# ***SOMERSET NORTHERN BYPASS PULASKI COUNTY, KENTUCKY***

Item Number 8-59.60

**VALUE ENGINEERING STUDY  
for  
Kentucky Transportation Cabinet  
Frankfort, Kentucky**

**Final Report**

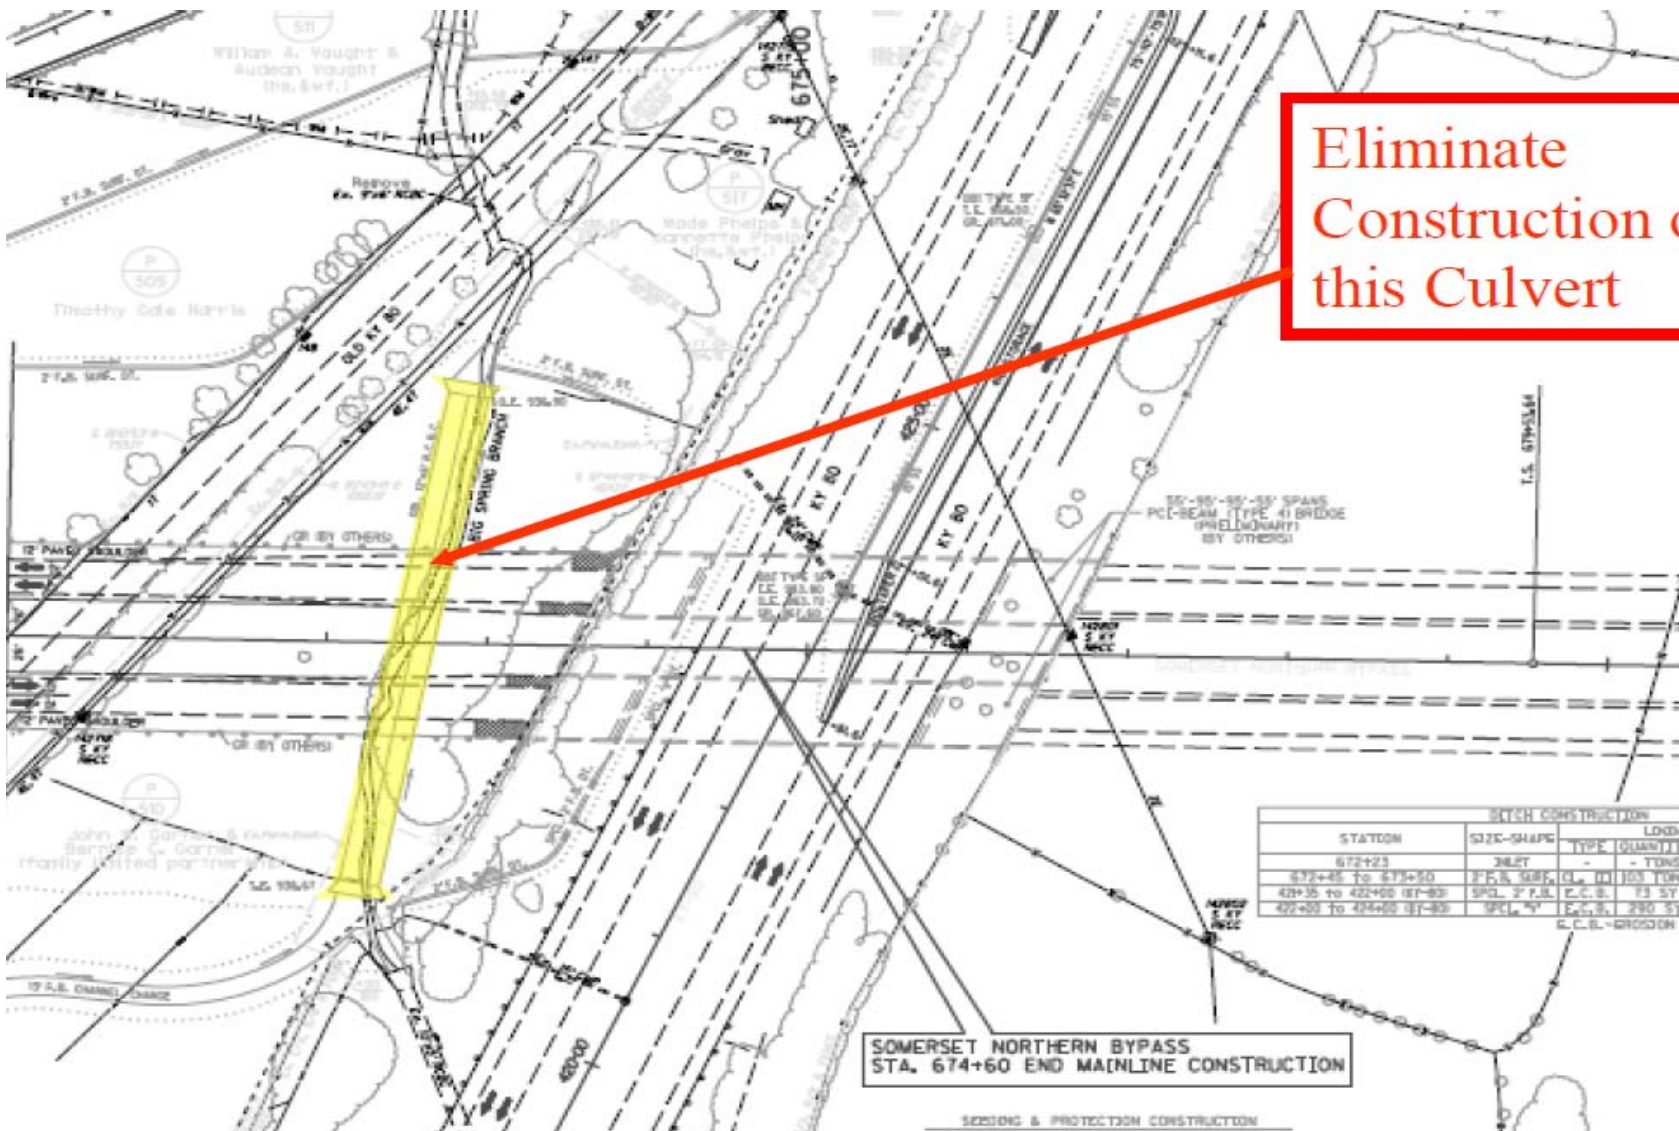
The original design specifies to construct a double 12' X 6' box culvert at Station 672+54. The plans show a Grade and Drain section only from Station 664+00 to Station 674+60. This section would be paved when the interchange over KY-80 is constructed for the future extension of I-66 towards London, KY.

The recommended change is justified since the only need for the box culvert is if and when the extension of I-66 toward London is constructed. Given the uncertainty of that project, it is possible it will never be constructed; therefore postponing the construction of the box culvert is a reasonable approach to reduce the cost of the current project which is under programmed anyway. It also will lessen the environmental impact to Big Spring Branch and the required mitigation costs for the current project.

## VALUE ENGINEERING DESIGN COMMENT # VE-23

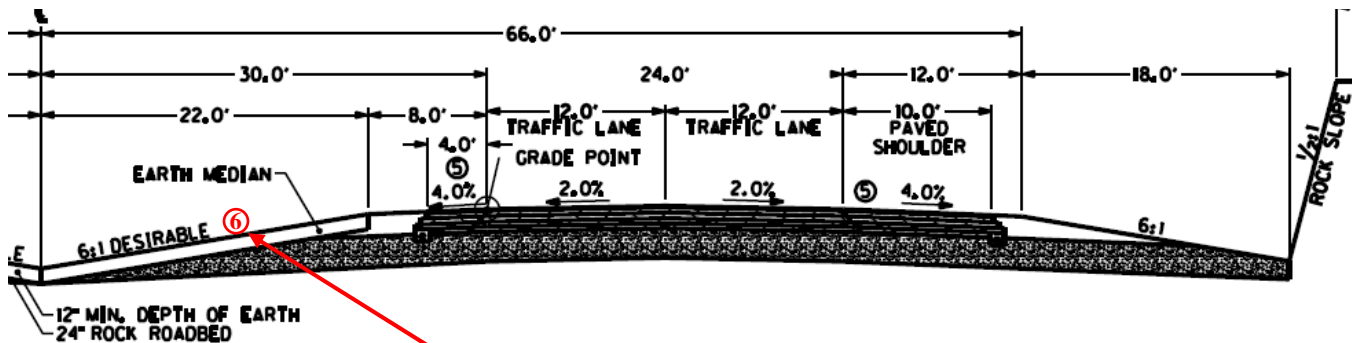
Label the location of Note 6 on the typical section plan.

Note 6 on the typical sections indicates that earth refill shall be soil suitable for establishing vegetation and must be free of stones 1 inch or greater in overall dimension. The VE team assumes this note applies to the median section of the typical section, but the number 6 is not identified on the plans. The VE team suggests including the number 6 on the plans or eliminating the 6 from the note.

Add Note Number Here

## **VALUE ENGINEERING DESIGN COMMENT # VE-24**

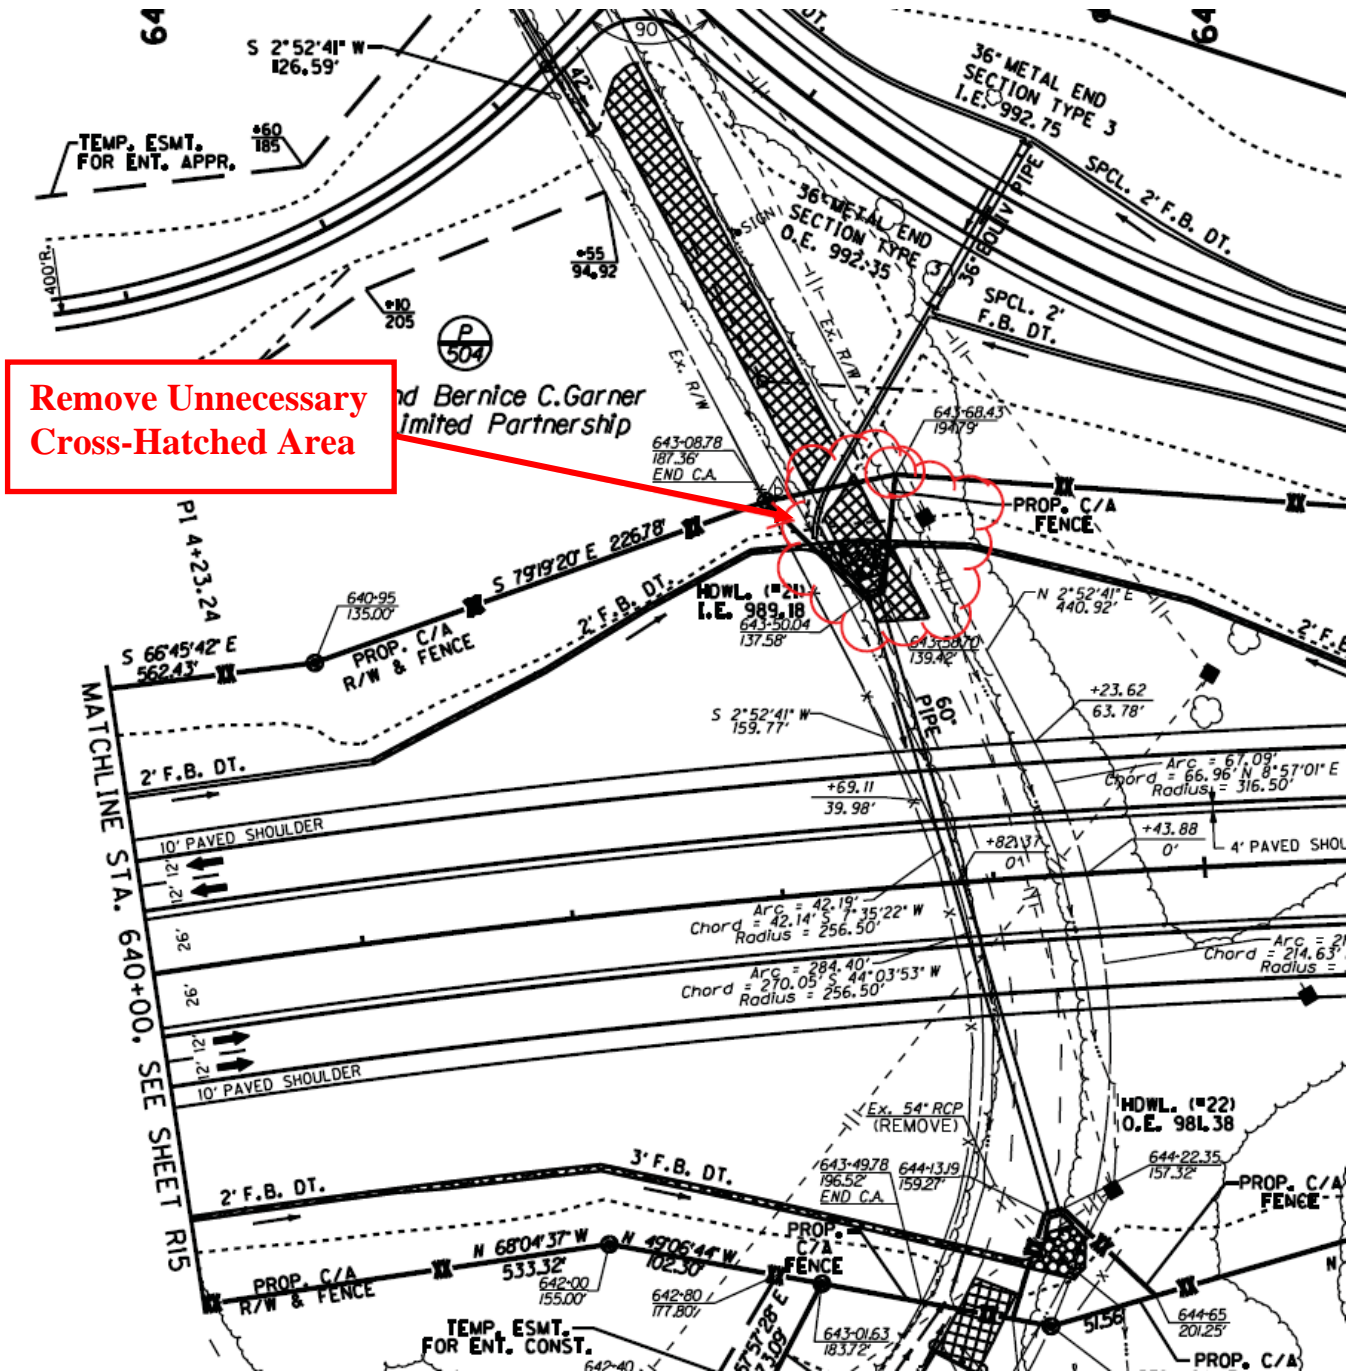
Due to the availability of rock on project site, it is recommended that the plan quantity of Class II and Class III Channel Lining be converted to equivalent quantity of Class IV Channel Lining and be added to plan quantity for the Class IV. The bid items for Class II and Class III would then be deleted. This recommendation is in accordance with previous Project Team Meeting notes.

## **VALUE ENGINEERING DESIGN COMMENT # VE-31**

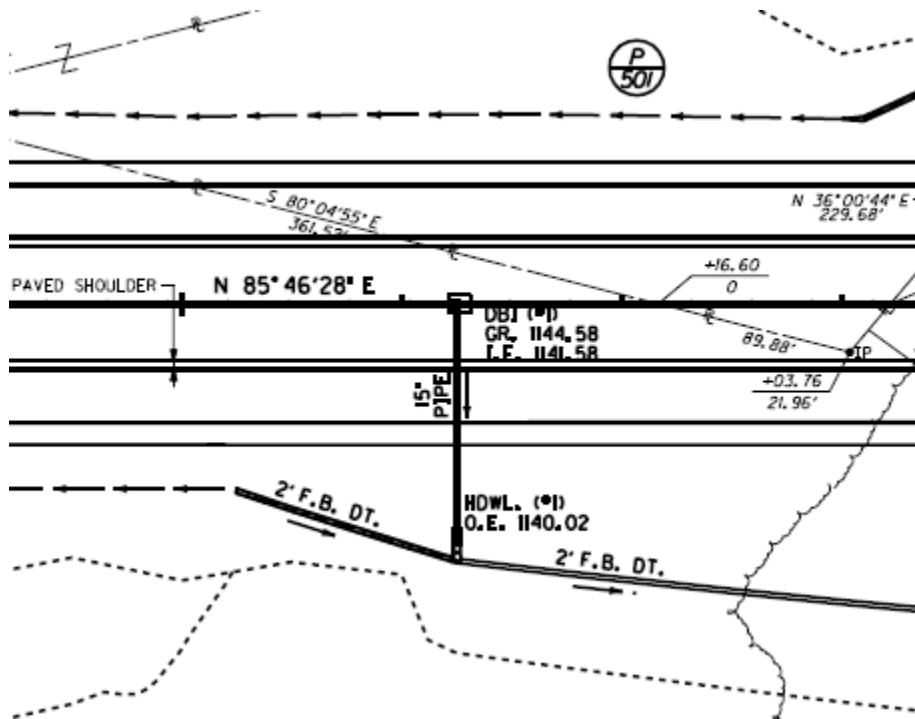
Value Engineering Recommendation VE-15 recommends eliminating the construction of the double 12' X 6' box culvert at Sta. 672+54 on this project. The future I-66 project toward London will require a new bridge to be constructed over KY-80 and the completion of the interchange. During the preparation of the Advance Situation Folder for that future project, the possibility of lengthening the bridge over KY-80 to span Big Spring Branch should be explored. The existing Big Spring Branch could be relocated closer to KY-80 to reduce the length of the tail span. The project team should weigh the balance between cost and environmental impact during this analysis phase.
